# Re: North East Albion Area Plan Review

## Proposed changes to the active transportation infrastructure in the North East Albion Area Plan:

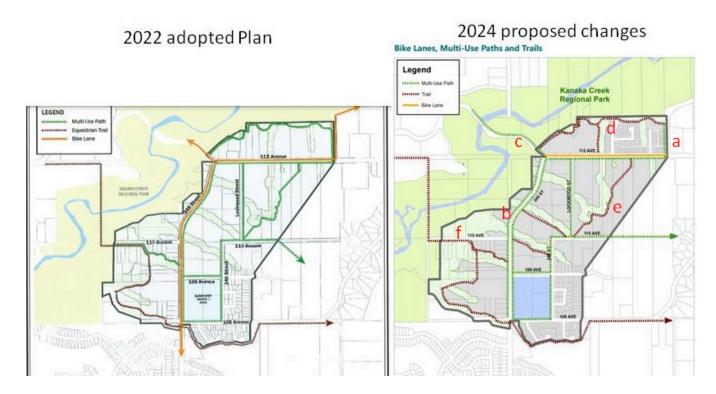
The map of the planned active transportation facilities in the Plan as it was adopted, shows bike lanes on 248 Street, 112 Ave. and on 252 Street, presumably continuing further east in future, as well as multi-use paths throughout the area.

- a. bike lane on 252 Street (and continuing along 112 Street further east) removed (the southbound bike lane on 252 Street has already been constructed, so not clear why it's not on the new map anymore)

- b. bike lane on 248 Street removed
- bike lane on 112 Ave. continuing west through the Kanaka Creek dip removed (we
  understand the rationale behind this, however we do have safety concerns for
  users of a narrow bi-directional MUP, including horses and (e-)bikes)

- d. the multi-use path along the northern border of the Area Plan is changed to a "trail" (we assume the only change here is the surface of the path, we would appreciate to have this confirmed. The targeted user group for this trail is all ages and abilities, however it is important to recognise that any change to surface type will limit accessibility for less able or experienced users.)

- e. the multi-use path that runs diagonally between 112 Ave. to the intersection of Lockwood/110 Ave. is changed to a "trail" (We were told during public consultation for the original plan, that the planned paved multi-use path would be a great

- alternate cycling route between 112 Ave./248 St., with a more gentle incline for people cycling. We would appreciate confirmation that this is still the case)
- f. a multi-use path from 248 Street connecting to 110 Ave. to the west is changed to a (horse?) trail. (We agree that a trail here makes more sense than a paved multi-use path)

- A convenient and comfortable through route for bikes, uni-directional, buffered, protected and segregated from pedestrians via 248 St., 112 Ave. and 252 Street. The separation could consist of flexible posts, and the buffer and the bike lane combined would allow for a usable width of about 2 meters.

- If MUPs are the default infrastructure where we have asked for designated, uni-directional, buffered and protected cycle lanes, they should be 4 meters wide in order to facilitate separate lanes for each direction of rolling users and pedestrian users, with markings showing clearly where pedestrians should walk and where rolling modes should go. This is necessary for the safety and accessibility of all users considering the high speed differential between rolling and pedestrian users.<sup>1</sup>

- We would like to see any roundabouts built within North East Albion to be designed so that people cycling are not forced in front of fast-moving traffic to manoeuver through the roundabout. People cycling on higher-speed, higher-volume roadways shouldn't be forced to merge with traffic. Instead, connections should be provided to a cycling facility, such as a multi-use pathway that bypasses the roundabout.<sup>2</sup>

- We would like the diagonal trail between 112 Ave. and 248 Street and the trail along the northern border of the North East Albion Area to be suitable for multi-use, including AAA cycling, in the new plan.

- Horse trails and multi-use trails (primarily suitable for walking and AAA cycling) should be clearly distinguished on the map and with signage.
